Thermal Compensation System Design Requirement and Conceptual Design Review Presentation

Phil Willems and Mike Smith

August 17, 2006 LSU

Arm Cavity Mode Structure, cont.

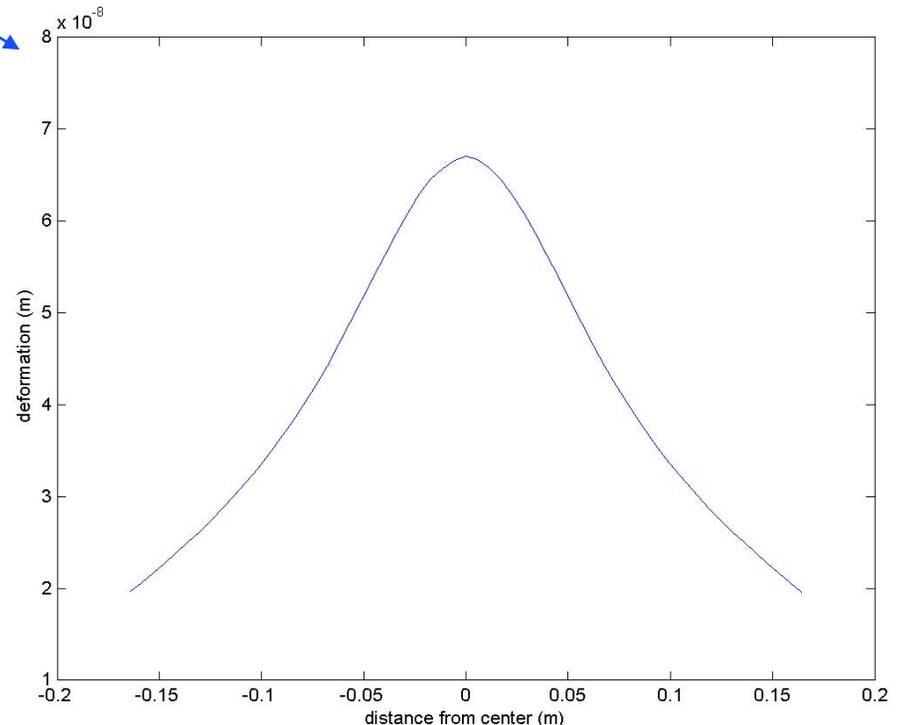
We would like to see more backup information/calculations for the stated requirement. E.g., it appears to us that a factor of 2 margin has been applied to come up with the 35km number -- is this correct? Including information on the absorbed power and thermal distortion in the first paragraph of this section would be useful; also a reference to where the calculation of the thermo-elastic deformation can be found. We strongly suggest that the thermal effect not be expressed as ROC, but rather as diopters or saggita change.

- The fundamental assumptions are:
 - » 6.0 cm cold spot size on the test masses
 - » .5 ppm absorption in the coating
 - » 2 ppm/cm absorption in the substrate
 - » 850 kW circulating arm power
 - » 2100 W traversing ITM substrate (counting both directions)
 - » Thus, .425 W absorbed in coating, .084 W in substrate

All these assumptions are specified in sections 2.5.1-3 (though the 850kW, 2100W figures are loosely calculated from numbers in 2.5.3.)

Dark Port Power Coupling Clarified

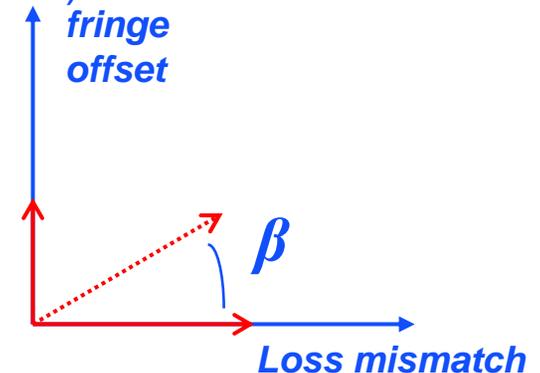
- The requirement (3.1.2.4):
 - » *TCS shall maintain the arm mismatch component of the homodyne dark port signal to within 1 mW of its nominal value.*
- Reviewers' comment:
 - » *We are not completely sure we are interpreting this requirement correctly, so please be prepared to clarify.*

- The DC readout scheme relies on weak carrier light to provide the homodyne LO for GW sideband detection. This reference light is partly from arm mismatch and partly from arm detuning. The ratio determines the homodyne phase angle.

TCS is required to maintain this value

Homogeneous Vs. Point Absorption

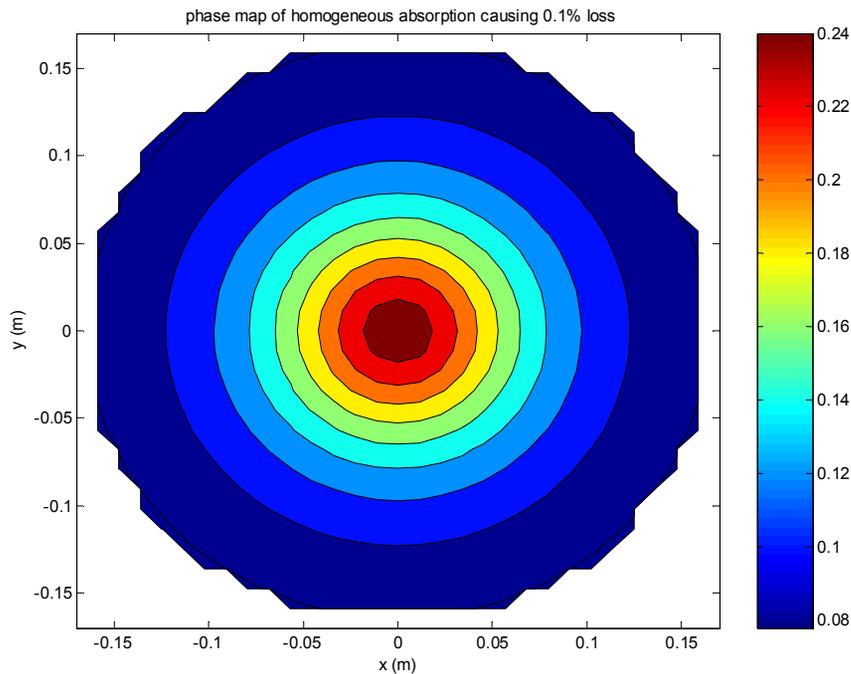
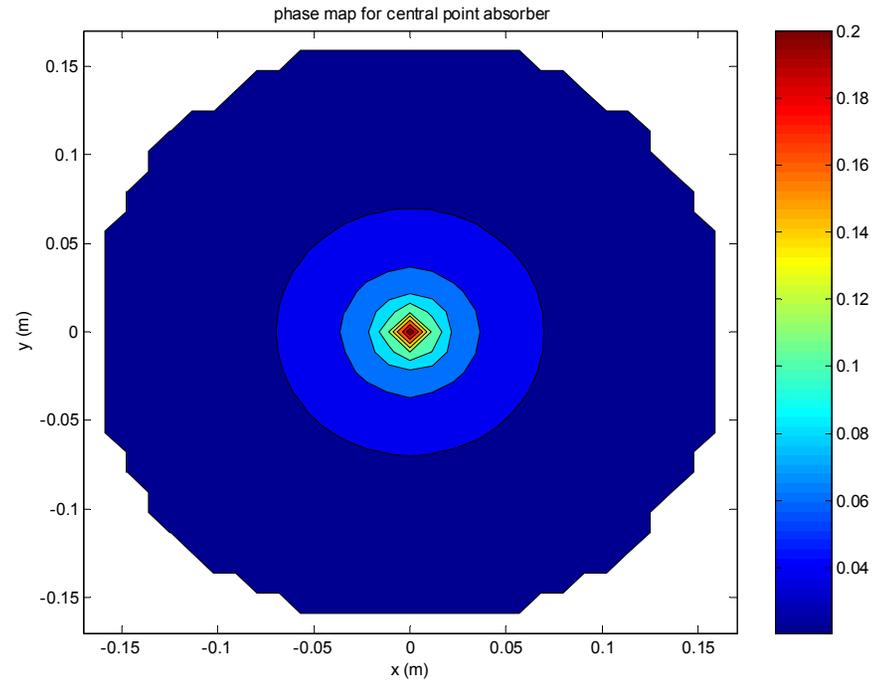
- From the DRD:
 - » *Based upon the thermal modeling reported in document LIGO-T-060068-00-R, the level of optical path variation that causes 5% loss of the gravitational wave sideband extraction efficiency in a marginally stable signal recycling cavity is approximately .08 radians for either homogeneous absorption or a single point absorber.*
- Reviewers' comment:
 - » *Also, please amplify the argument that point absorbers have about the same effect as homogenous absorption; there must be some stipulation that the 'point' be near the beam center.*
- Our response:
 - » Yes, a central point absorber is the worst case.

Both phase maps scatter the same 0.1% power from the carrier mode-

Stay Clear Zones

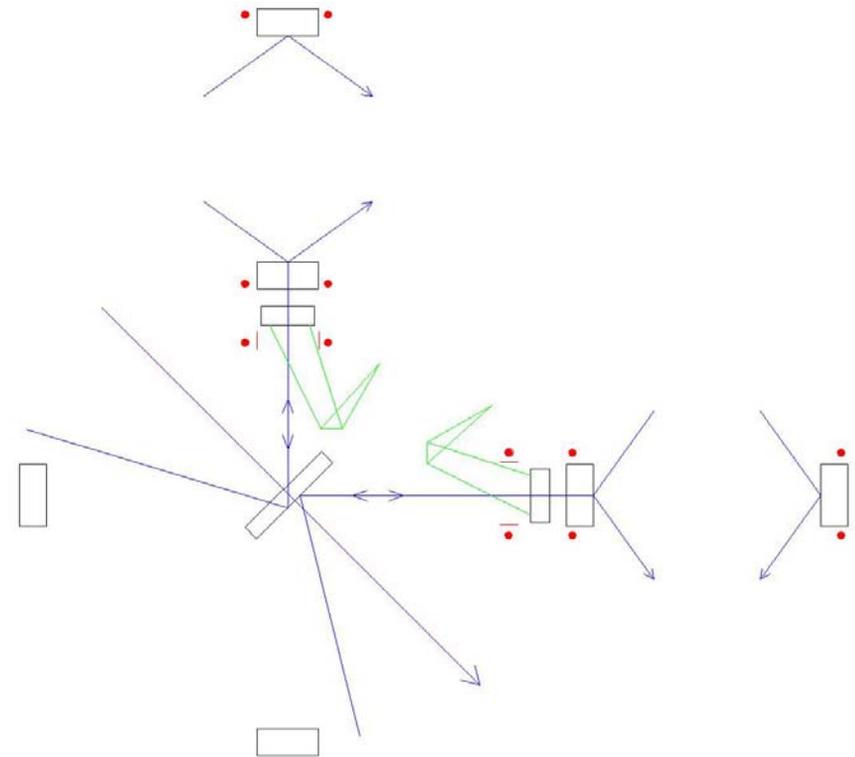
- Requirement, from 3.1.6.1.4:
 - » *The ring heater and shielding for the compensator plates will stay outside the scatter zone for the power recycling cavity beam.*
- Reviewers' comment:
 - » *What is the 'scatter zone for the power recycling cavity beam' ?*
- Our response:
 - » This is the region within the shielding provided by the elliptical baffle at the ITM.

Overall TCS Strategy

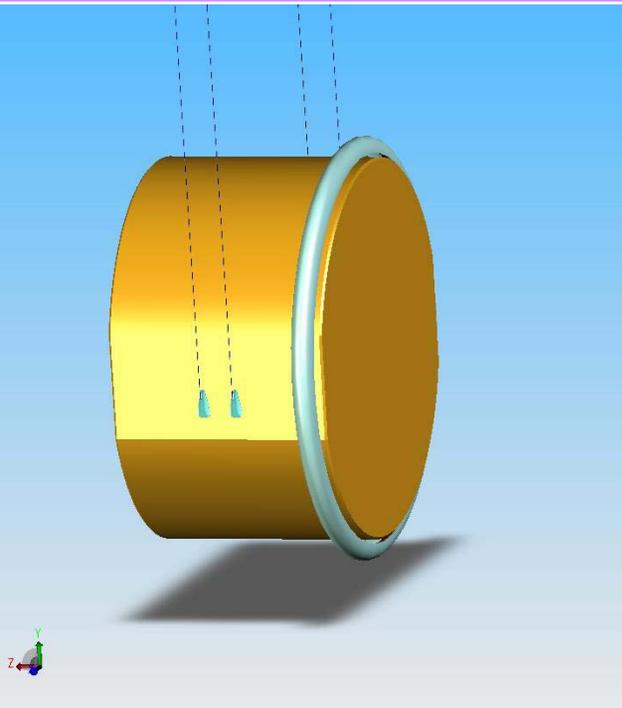
- » *Basic idea: Phase Cameras for the mode profile of the main IFO beam, dedicated sensors for subsets of optics. Dedicated sensors can further be separated in on-axis sensors and off-axis sensors. Makes sense but performance in terms of sensitivity and dynamic range for these sensors is missing.*

- » Sensitivity: $\lambda/1000$ for on-axis sensors, $\lambda/64$ for off-axis
- » Dynamic range: not specified in documents but can be set by uncompensated aberrations to 800 nm for on-axis sensor, 50 nm for off-axis
- » Phase camera sensitivity and dynamic range yet unspecified.

Compensated Arm Cavity Mode

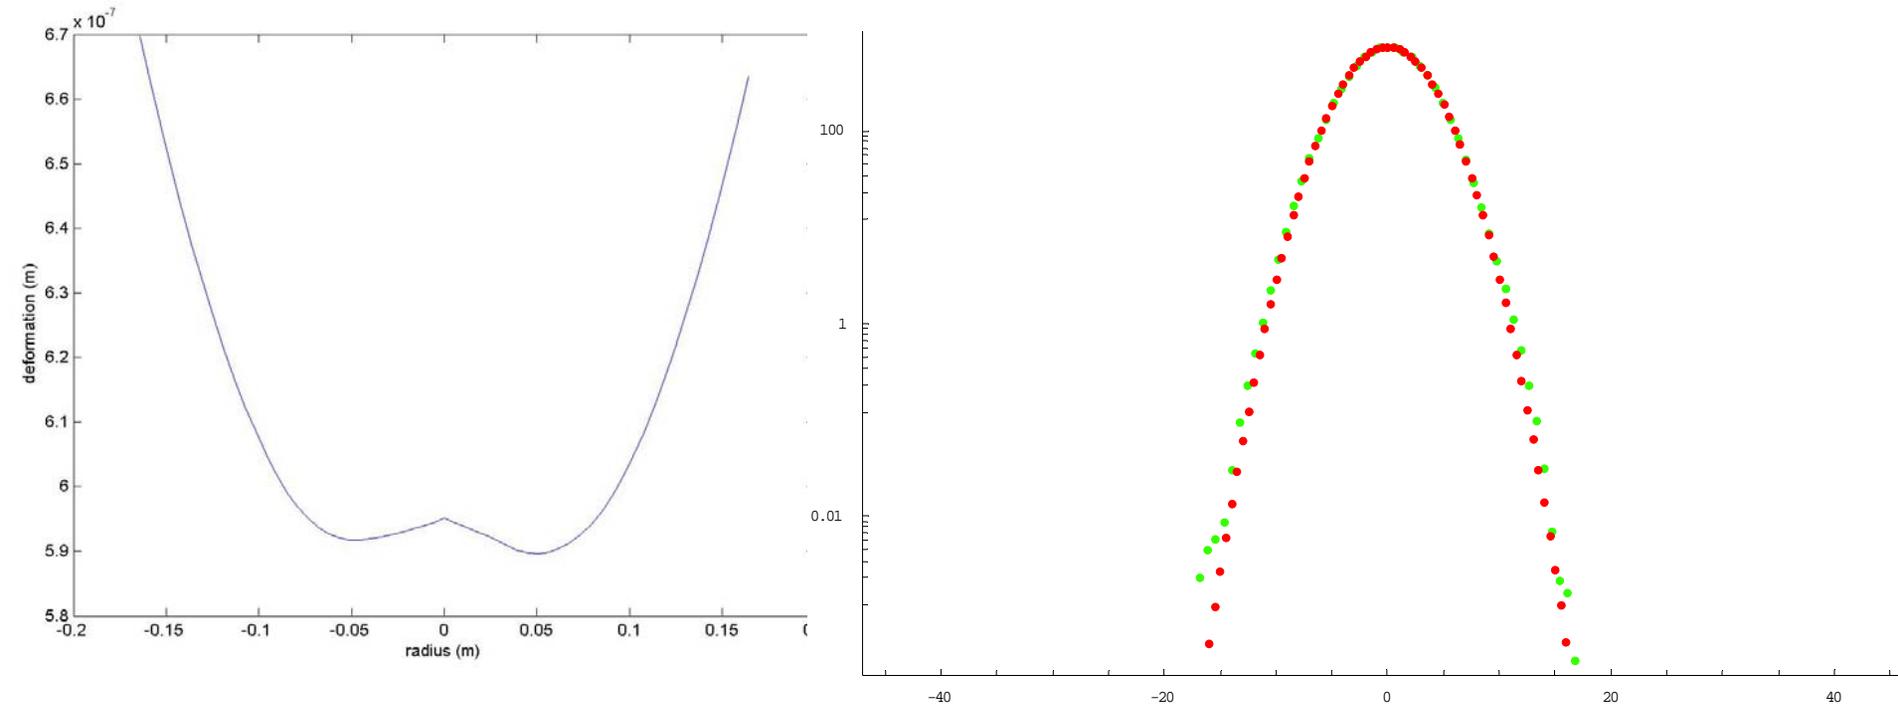
» *Fig. 5. Looks Gaussian, but can you tell us how much power is in higher order modes? Does it meet the requirement?*

Sensor Design

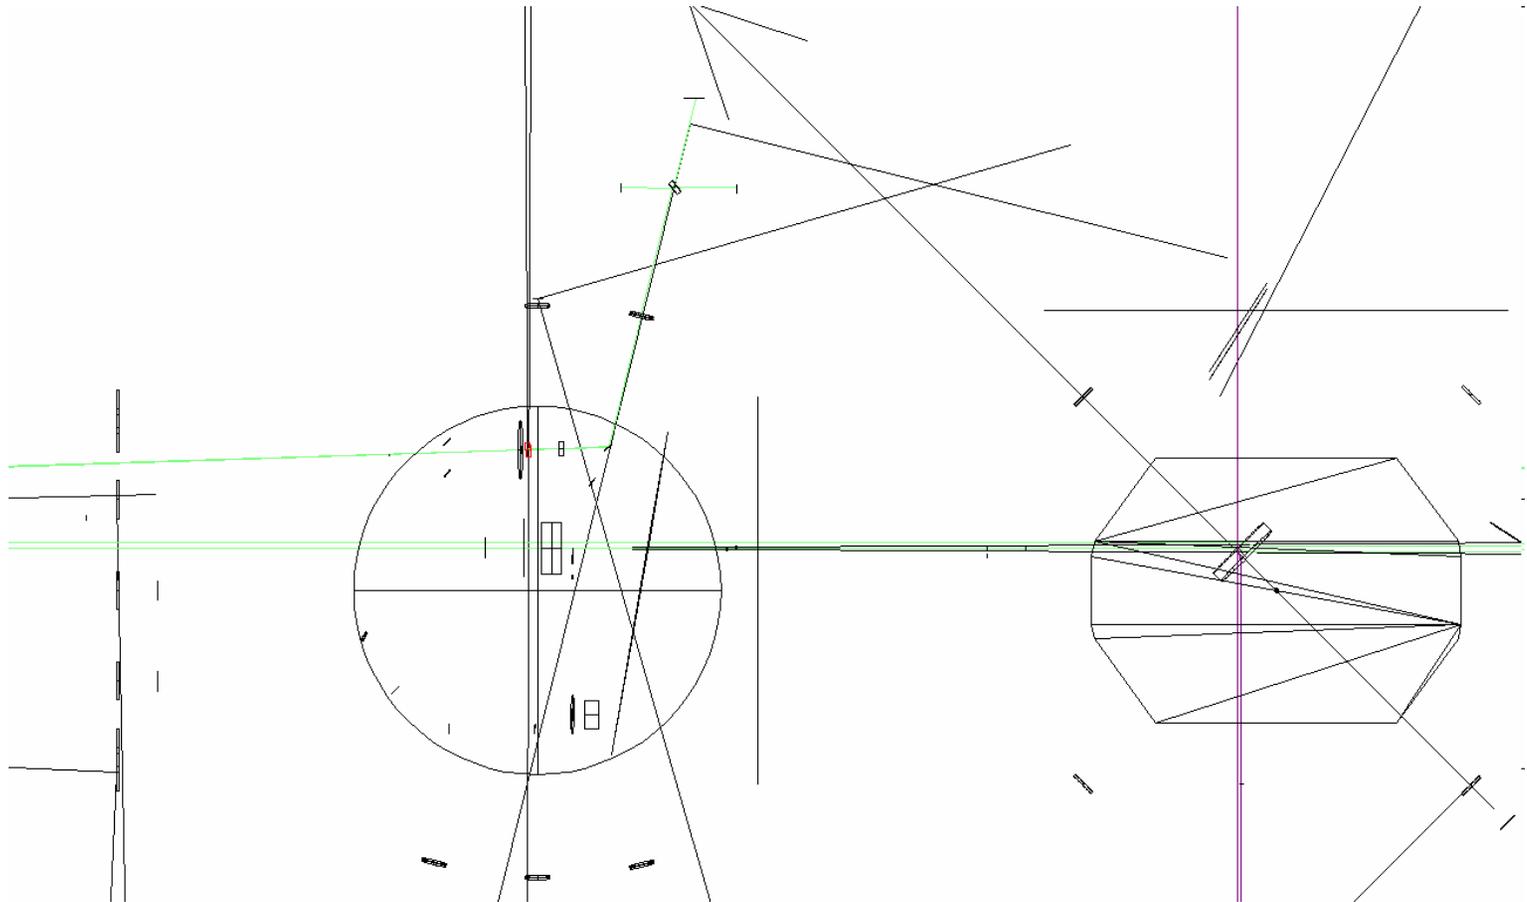
- Reviewer comment:
 - » *It is noted that the ITM/CP probe beams sense the BS aberrations differently than the interferometer beams, which could give sensing errors of 10-20%. Thus a separate BS sensor is proposed. But how accurate does the BS sensor need to be, to be able to extract the desired accuracy for the ITM/CP aberration of each arm?*
- The BS sensor needs to have comparable accuracy to the ITM/CP sensors.

ITMx Hartmann Probe Beam

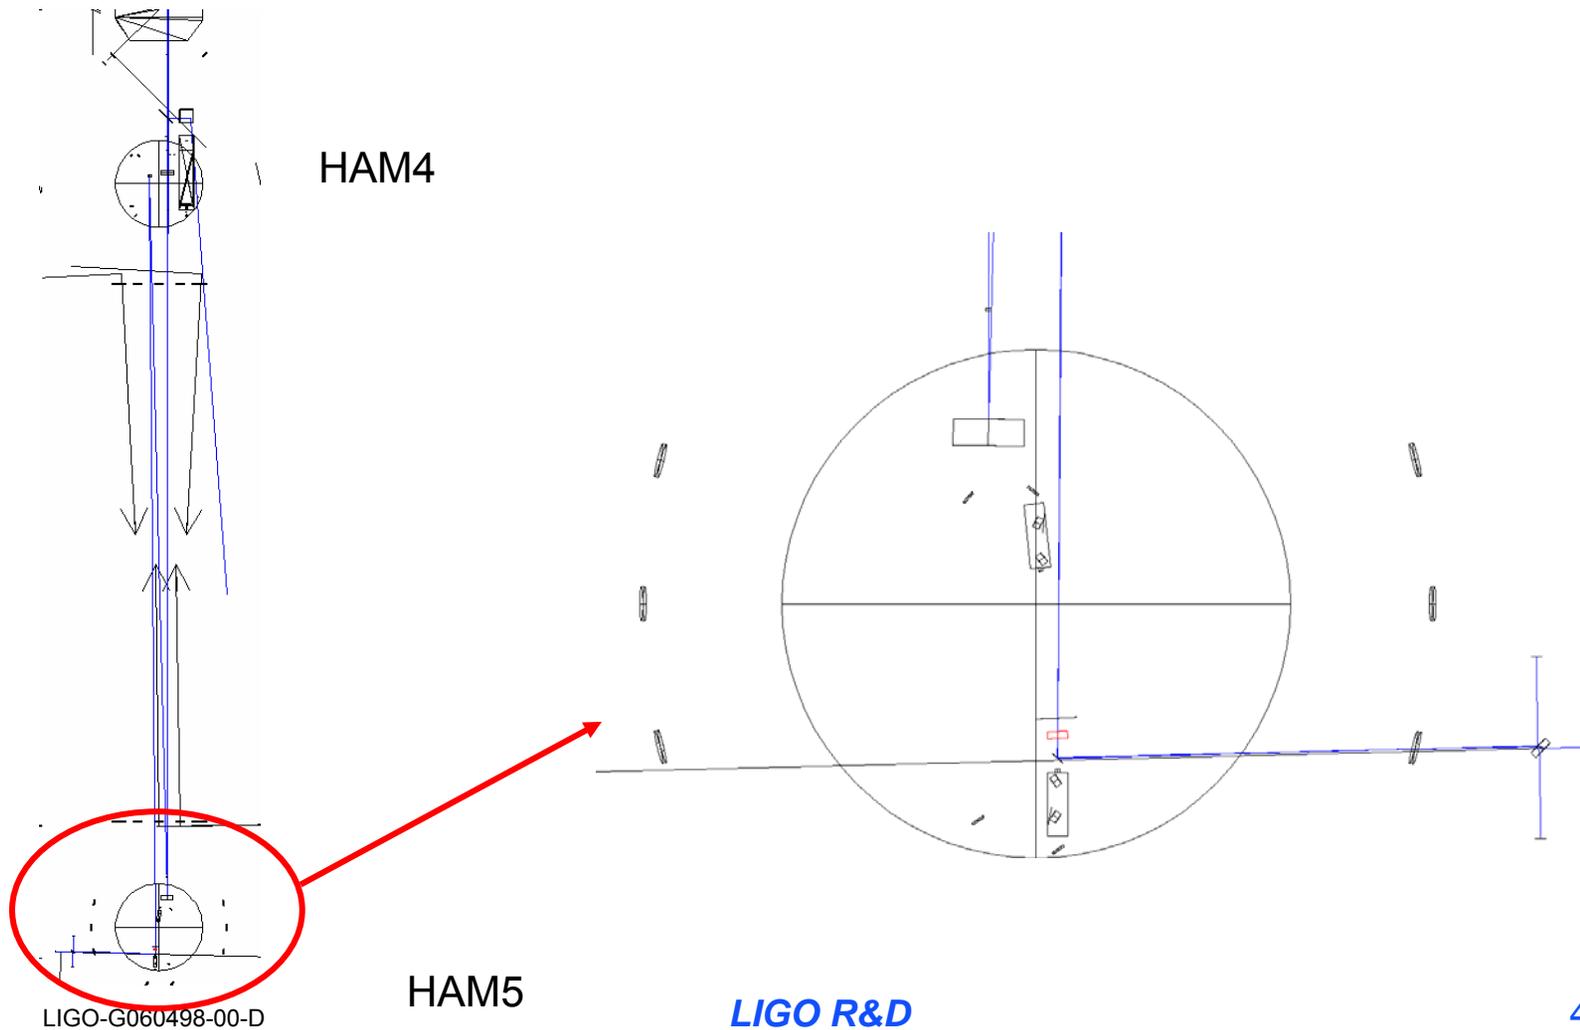
» *An alternative design for the probe beams would be to inject them through the mode-matching telescopes (MMT2), let them be expanded by the MMTs, and point them to be nearly colinear with the interferometer beams. This could be done from both the symmetric and anti-symmetric ports, to probe each arm. The coating reflectivities of the BS, MMTs, and RMs, would need to be specified appropriately for this to work, but the advantages would be that the probe beams sample the right paths, and lots of in-vacuum components currently needed for the probe beams could be eliminated. We'd like to discuss this alternative.*
